BIG ISLAND MINING PROJECT

ENGINEERING CLOSURE REPORT  
BIG ISLAND MINING (XAT-7)  
AND  
ATCHAFALAYA SEDIMENT DELIVERY (PAT-2)

AS-BUILT CONSTRUCTION PHASE

ENGINEERING CLOSURE REPORT  
BIG ISLAND MINING (XAT-7)  
AND  
ATCHAFALAYA SEDIMENT DELIVERY PROJECTS

**PARTIAL PLAN**  
**REVISION TO NATAL CHANNEL**  
 (FIELD CHANGE NO. 2)

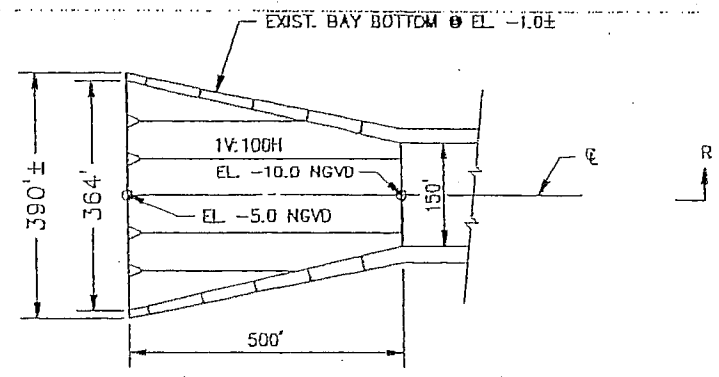
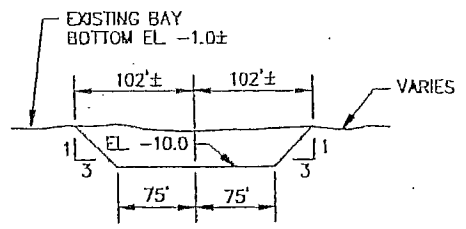
RE: BIM/ASD Project Field Change No. 2  
Revision to Natal Channel Alignment Between Sta. 70+00 and End.  
BCG Project 30594-1.

As the Engineer of Record and in accordance with the project specifications we are forwarding Field Change No. 2 to you for implementation into the project. This change calls for extending and revising the bottom width of Natal Channel from station 74+00 to the new end station 88+00. Also, adding Branch A channel at station 70+00 with a deflection angle of 45° and extending for 1500 feet in an effort to reach deeper bay bottoms. The new channel bottom width between Sta 74+00 and end, and the Branch A channel between Sta 0+00A and end is reduced to a 150 foot bottom at a design depth of -10.00 NGVD. The channel side slopes remain at 4V:3H. In addition, there is a flair end transition on both channels as shown on the enclosed Field Change No. 2 drawing dated March 10, 1998. This change in cross section and channel extension is estimated to require the total dredging in Natal Channel of approximately 657,000 cubic yards; and is to be constructed at the unit bid price of \$1.50 per cubic yard. This change results in no changes to the contract unit prices and stays within the estimated bid quantity item no. 510 of the contract.

**SECTION R-R**  
 (NTS)

**SECTION Q-Q**  
 STATION 74+00 TO 83+00 NATAL CHANNEL  
 STATION 0+00 A TO 10+00 A  
 (NTS)

**IGHAM AND GANNUCH**  
**CHANGE NO. 3**  
**ANNEL D AND REVISIONS**  
**DA-4 AND DA-5**

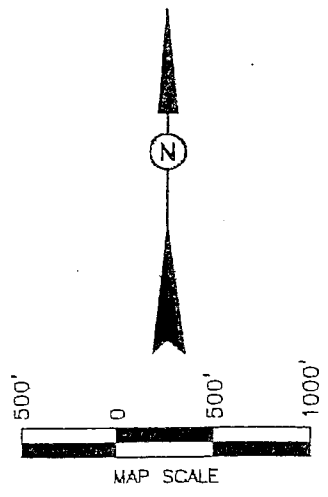
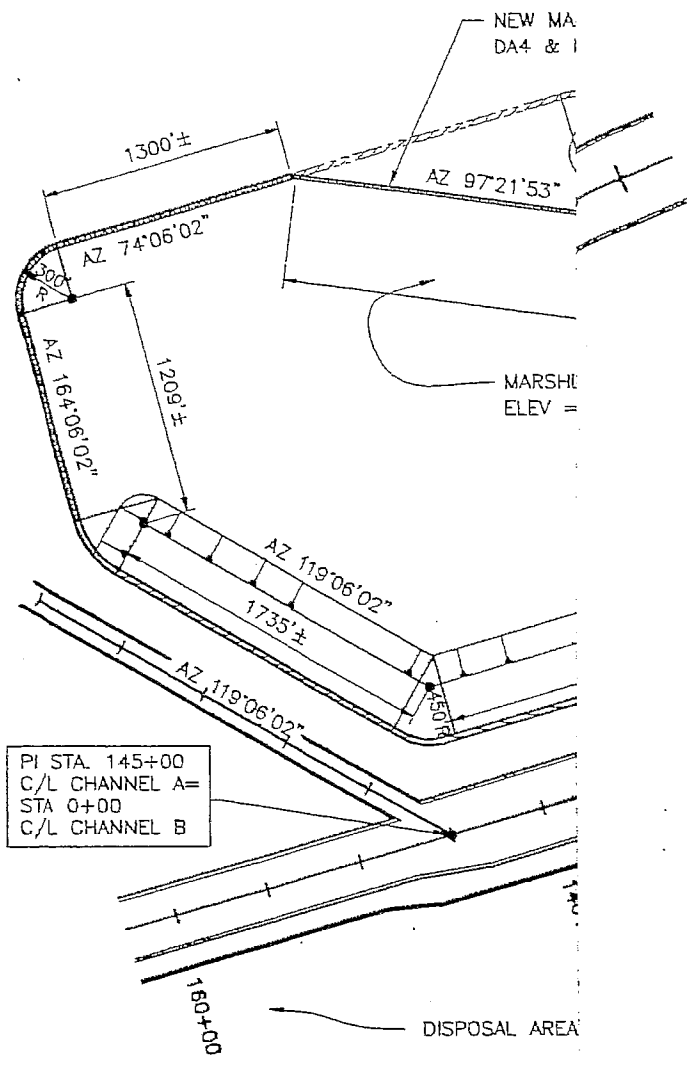
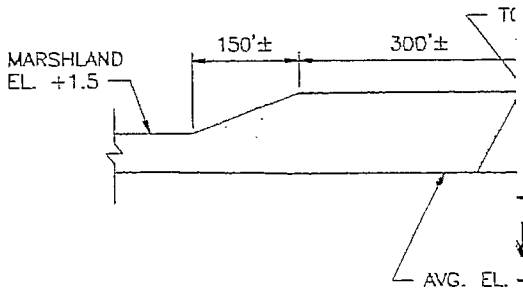
RE: BIM/ASD Project Field Change No. 3  
Revise Channel D Alignment,  
Delete Disposal Area No. 3  
And Revise Disposal Area No. 4/5

1. Realigning the originally configured Channel D of the construction plans, to begin work at Channel A c/l station 67+20 and construct a 200' bottom to Elev. -10.0 NGVD. The new Channel D extends along a centerline as azimuth of 97° 21' 53" for 4000 feet, ending work at Channel D (c/l station 40+00).

2. Delete Disposal Area No. 3 from the project in its entirety.
3. Modify Disposal Area 4/5 to be contiguous to the new Channel D alignment, all as shown on "Field Change Drawing No. 3", dated June 1998 (copy attached).

5. Disposal Area 4/5 is revised and expanded along its perimeter to be contiguous to the new Channel D alignment, the optional back dike alignment for DA No. 4/5 has been shifted to follow the -1.0 NGVD contour elevation of the bay bottom. Some field deviation from alignment shown may be required to stay in shallow water (-1.0 NGVD).

1. DELETE DISPOSAL AREA NO. 3  
(AREA = 3,596,600 SQ. FT.)
2. REVISED DISPOSAL AREA 4 AND 5  
AREA:  
     LOBE ISLAND = 3,968,200 SQ. FT.  
     MARSHLAND = 9,590,800 SQ. FT.
3. ALL ELEVATIONS IN NGVD
4. ALL INSTRUCTIONS ON ORIGINAL PLANS  
REMAIN IN EFFECT EXCEPT WHERE  
MODIFIED ON FIELD CHANGE NO. 3.
5. ALTERNATE CHANNEL D VOLUME  
ESTIMATED TO BE 175,000 C.Y.

FIELD CHANGE NO. 4 - DRAWING NO. 1

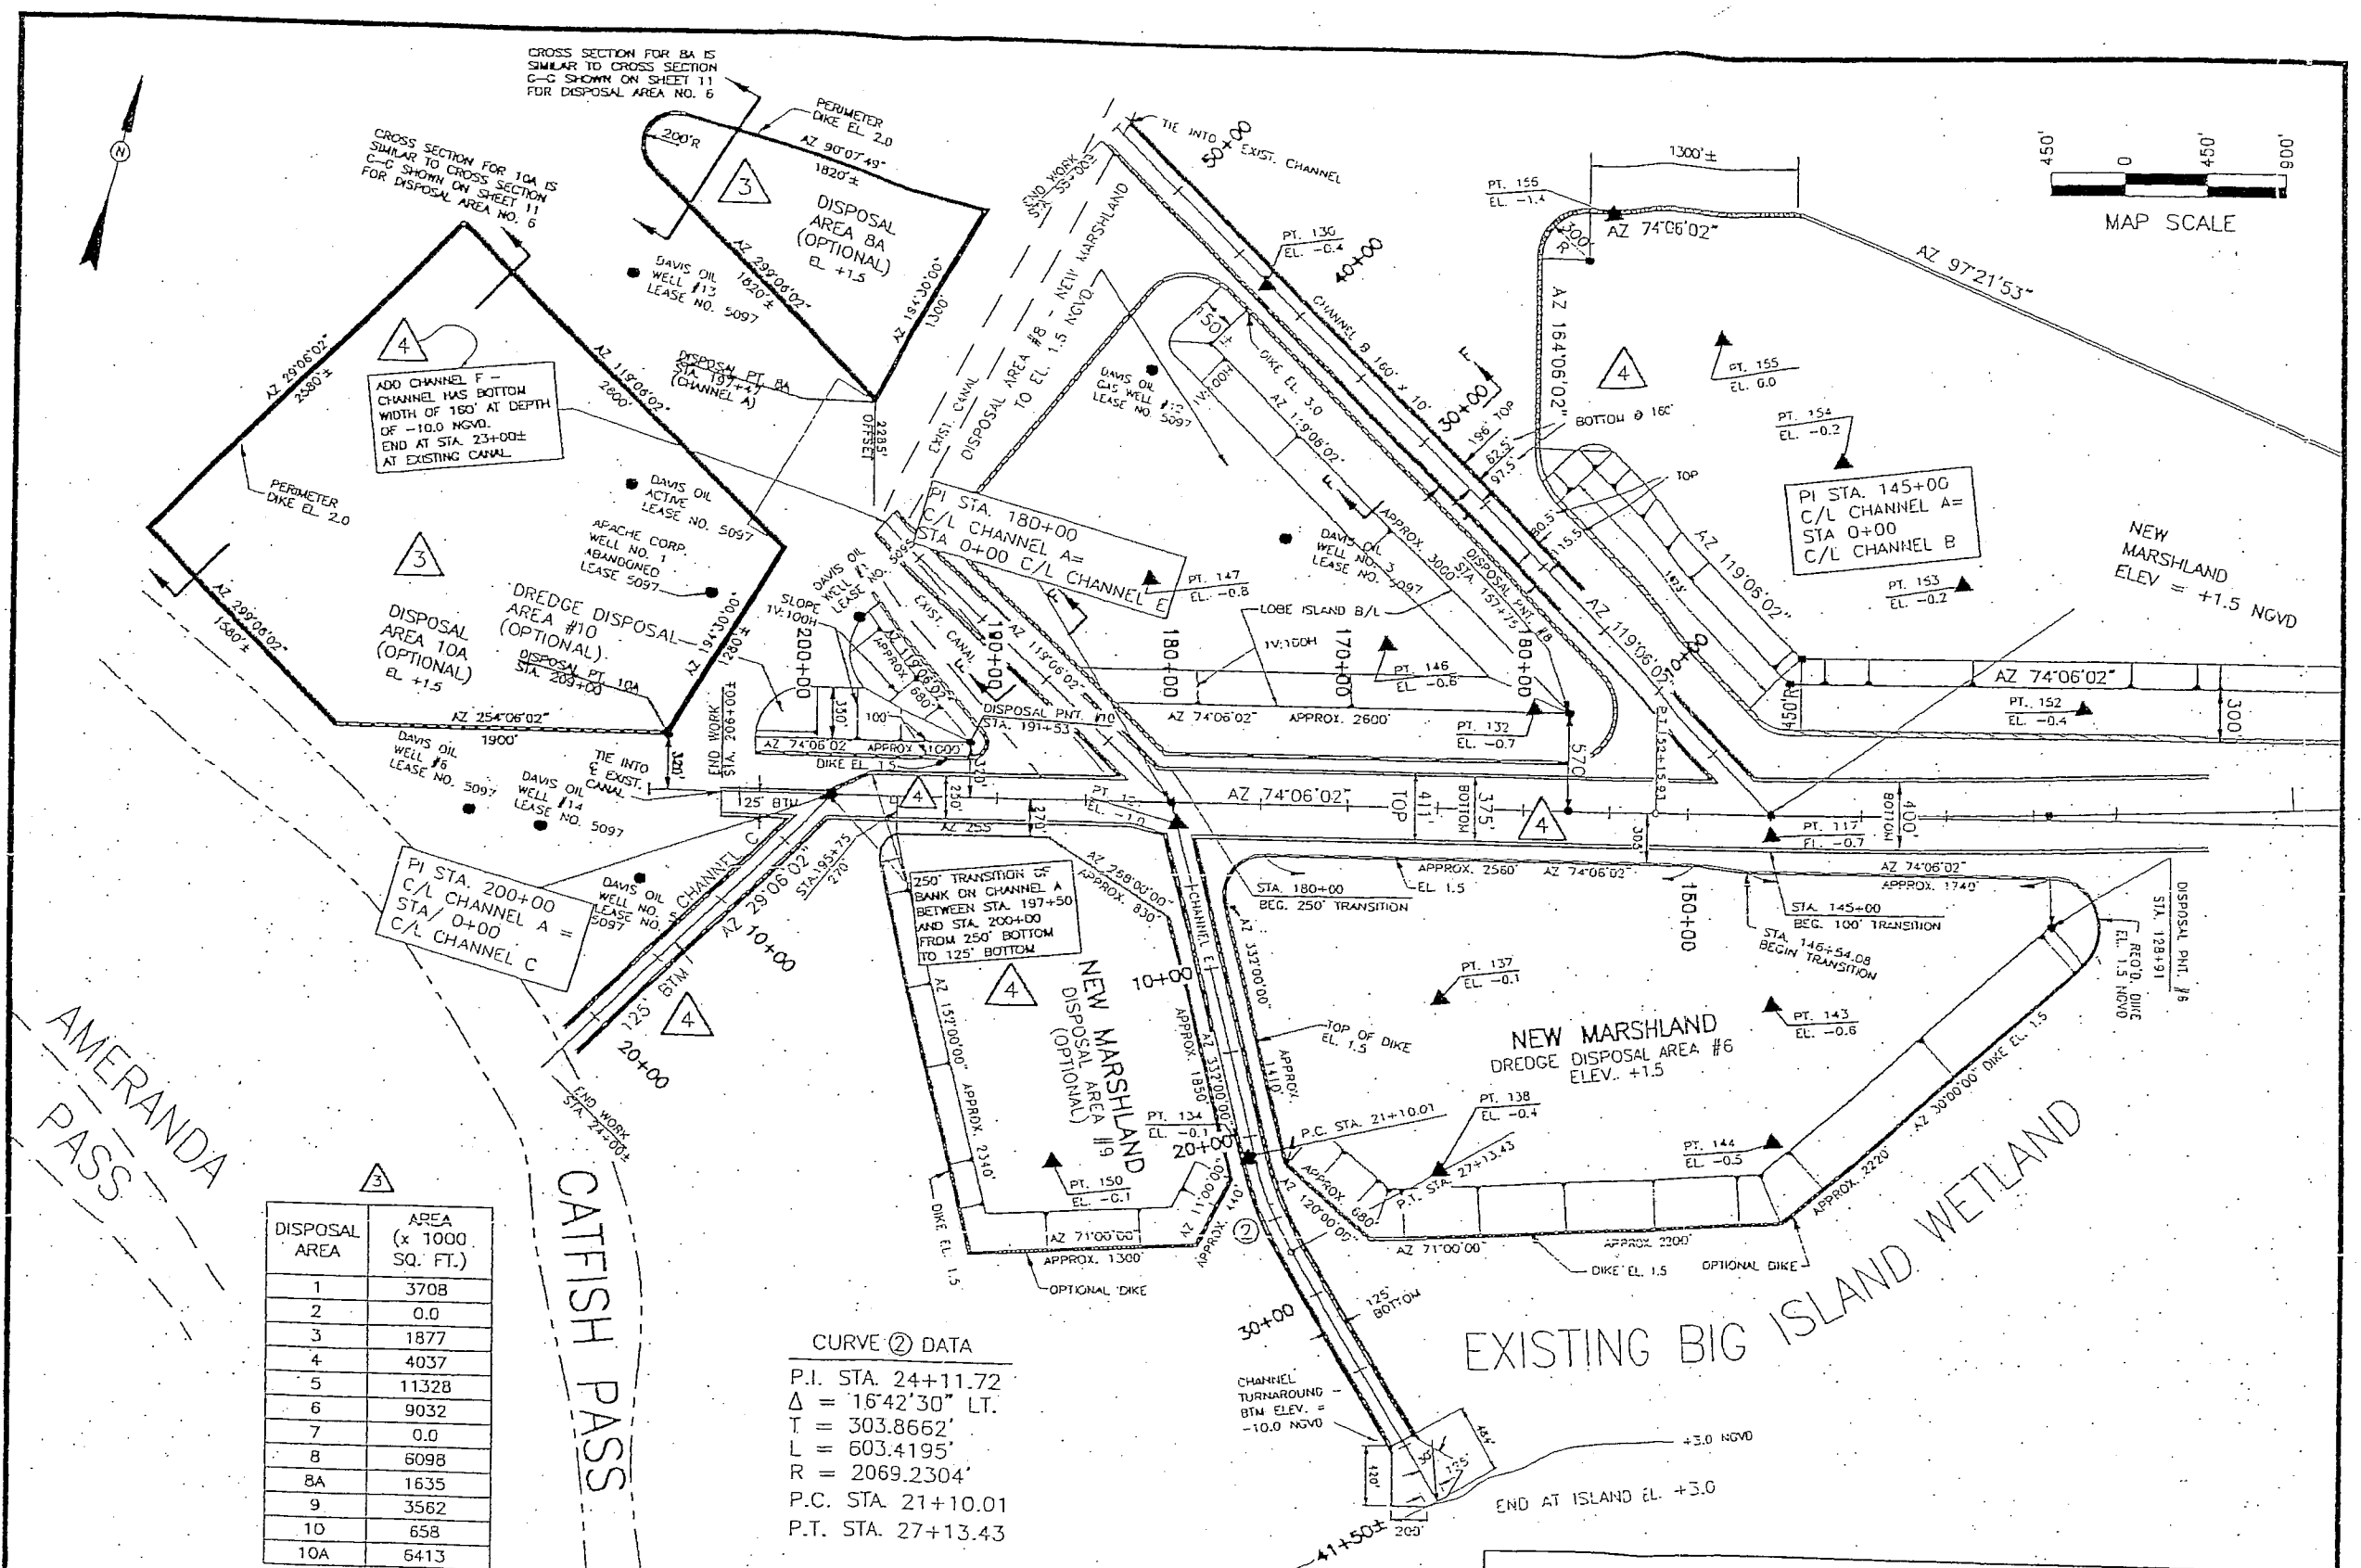
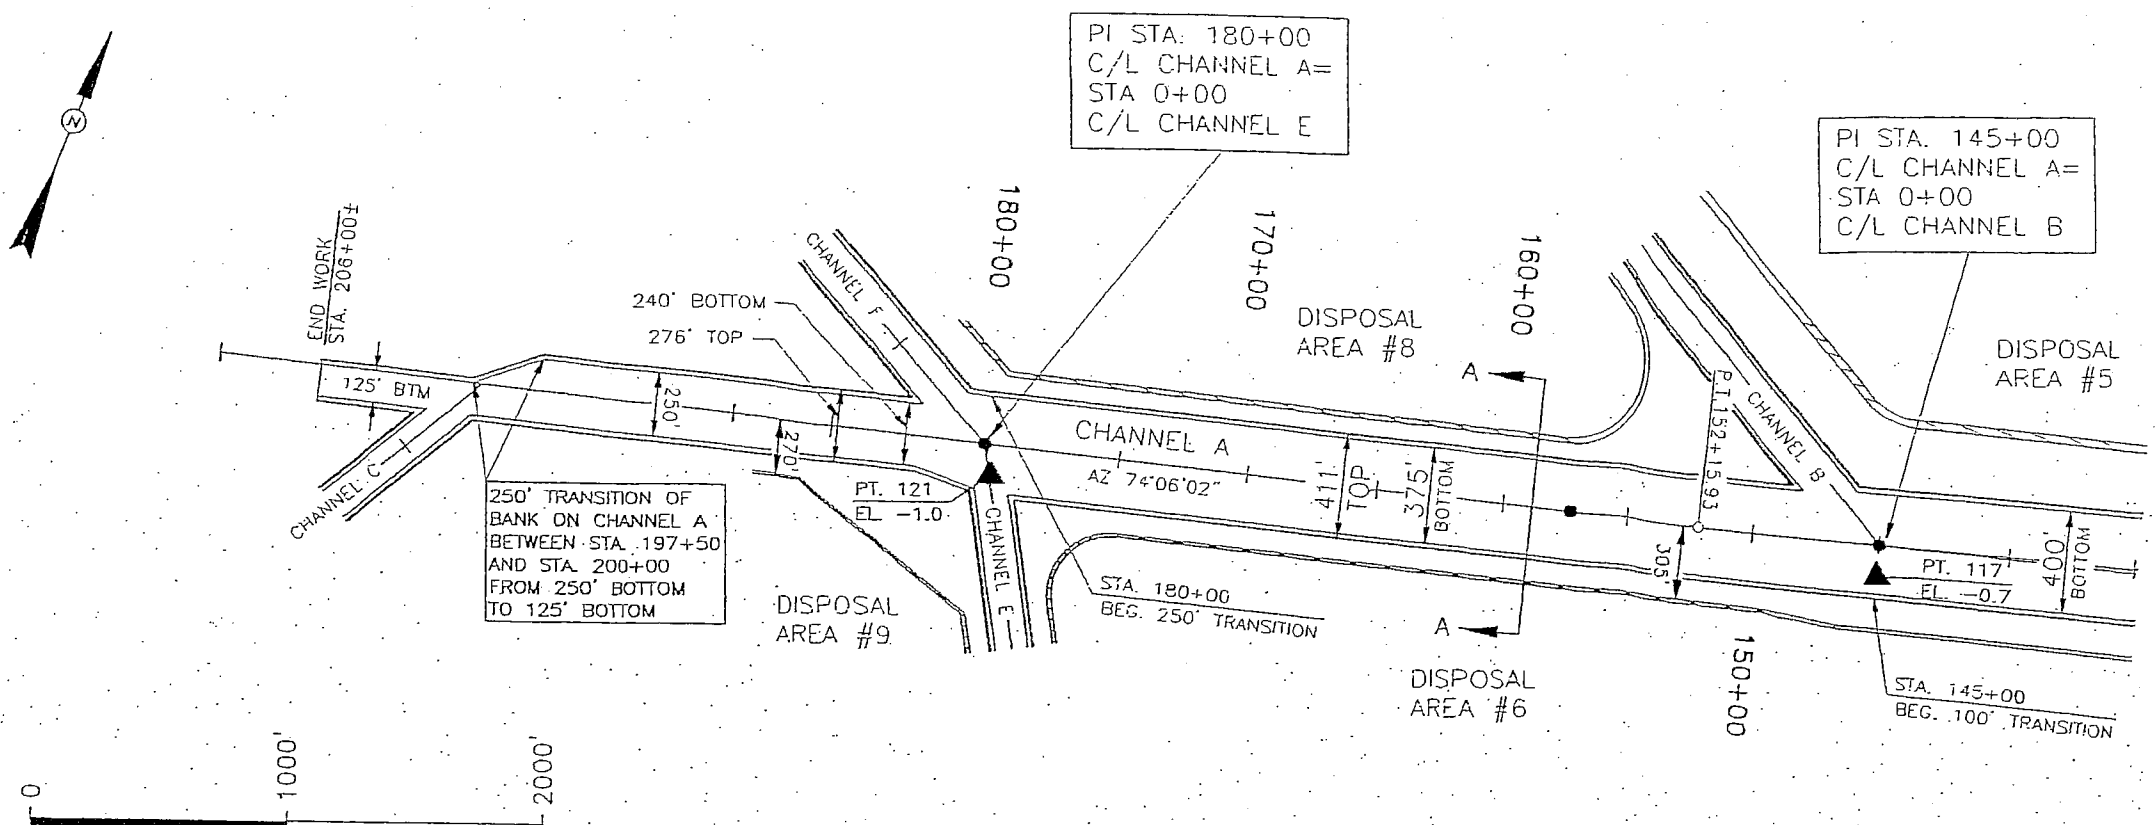
Re: BIM/ASD Project Field Change No. 4  
Revised Channel Widths For "A", "B", "C", and "E" and add Channel F.

In addition, add new Channel F starting at station 180+00 of Channel A and extending on an azimuth of 119° 06' 02" to station 22+00± to intersect with the existing pipeline canal. Channel F shall have a bottom width of 160 feet to -10.0 NGVD. Also, extend the Disposal Area No. 8 dike along new Channel F with the bucket dredge to station 20+00 of Channel F. Contractor shall conduct a magnetometer survey prior to doing work along Channel F to insure that no pipelines exist.

OVERALL VIEW - REVISION TO WIDTHS OF CHANNELS A, B, C, E AND NEW CHANNEL F

BROWN, CUNNINGHAM AND GANNUCCI			
FIELD CHANGE NO. 4 - DRAWING NO. 3			
REVISION TO WIDTH OF CHANNEL A - STA. 145+00 TO STA. 206+00			
DATE: JUNE, 1998	DESIGNED: EJM	DRAWN: CDH/WC	SHEET:
ACAD FILE: D:\JOBS1\30594B1&ASD\FIELDCHANGES\FLDCHG4

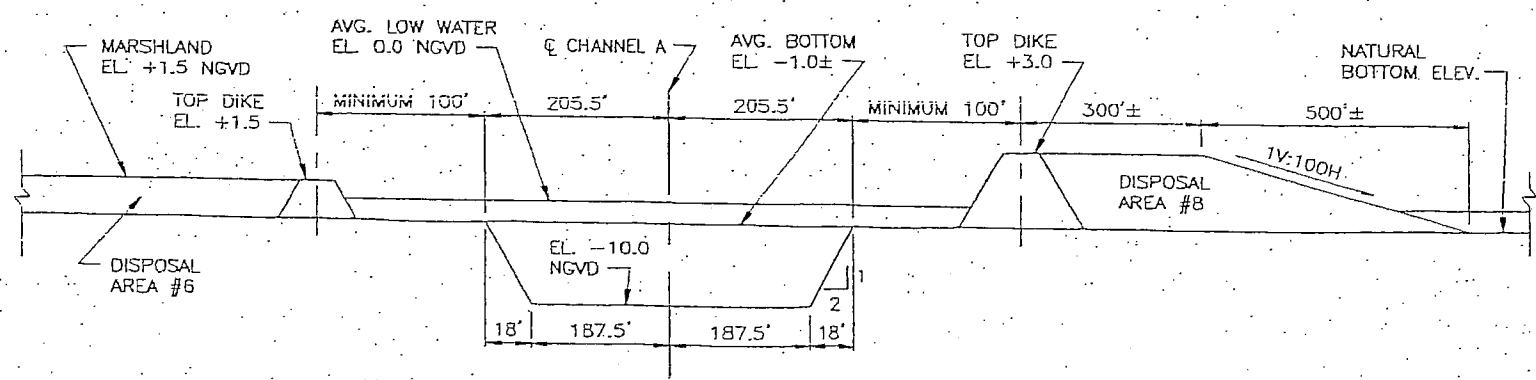
PARTIAL PLAN CHANNEL A  
SCALE: 1" = 1000'

SECTION A-A CHANNEL A  
NTS

BROWN, CUNNINGHAM AND GANNUCH			
FIELD CHANGE NO. 4 - DRAWING NO. 4			
REVISION TO WIDTH OF CHANNEL E			
DATE: JUNE, 1998	DESIGNED: EJM	DRAWN: CDH/WC	SHEET: 4 OF 5
ACAD FILE: D:\JOBS1\30594BI&ASD\FIELDCHANGES\FLDCHG4-4.DWG

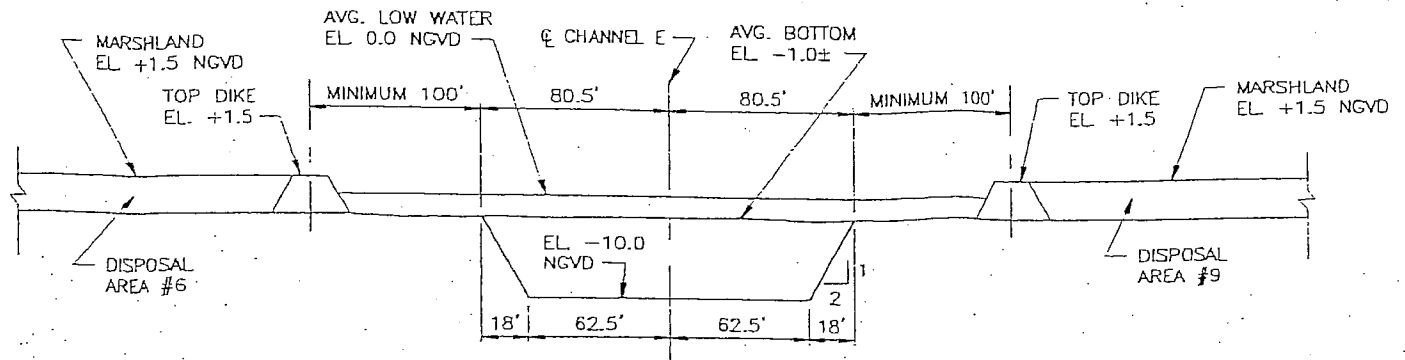
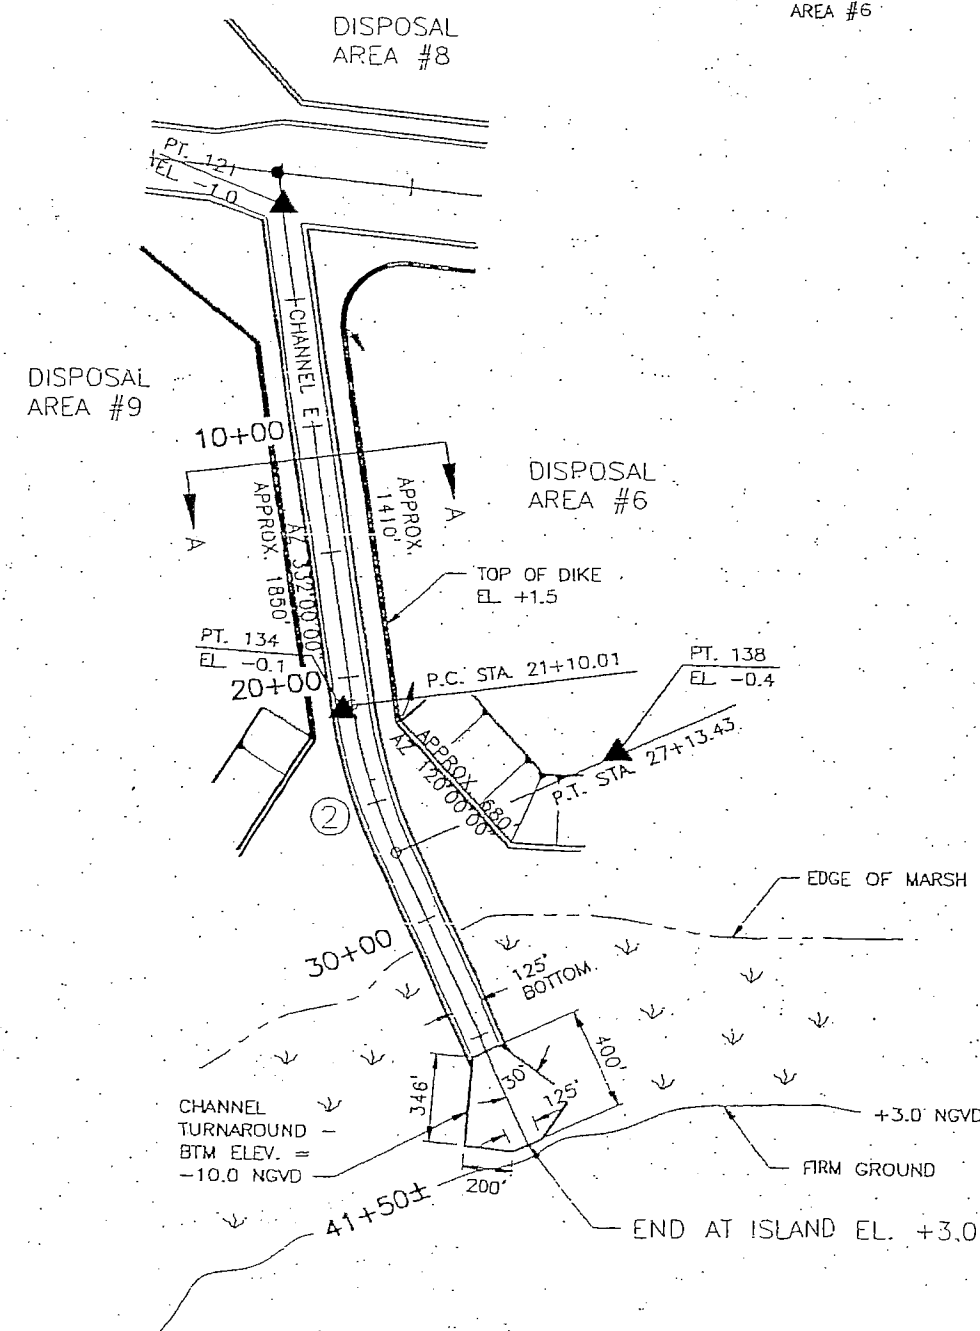
SECTION A-A CHANNEL E  
NTS

PARTIAL PLAN CHANNEL E  
SCALE: 1" = 1000'
